## REVISION TRANSMITTAL

This sheet transmits Revision 1 to SB700-49-01, which:

AUXILIARY POWER - MODIFICATION OF THE AUXILIARY POWER UNIT (APU) STARTING SYSTEM

SB700-49-01  
Page 1 of 10

Figure 1. Auxiliary Power Unit (APU) Wiring Modification (Sheet 1)

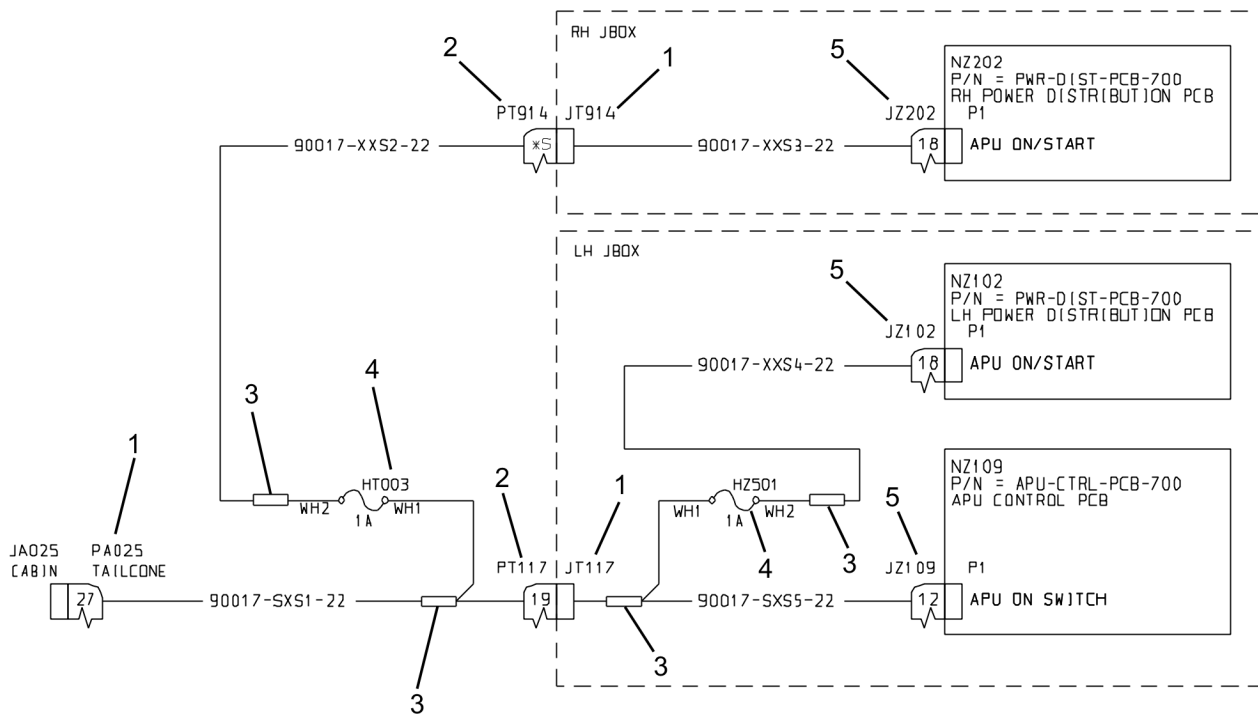
- G. (Refer to Figure 1, Sheets 1 thru 3.) Do the electrical wiring modification per wiring diagrams.
- H. Install the left and right PCB enclosures using the four screws to attach the left and right PCB enclosure to the DC power junction box.
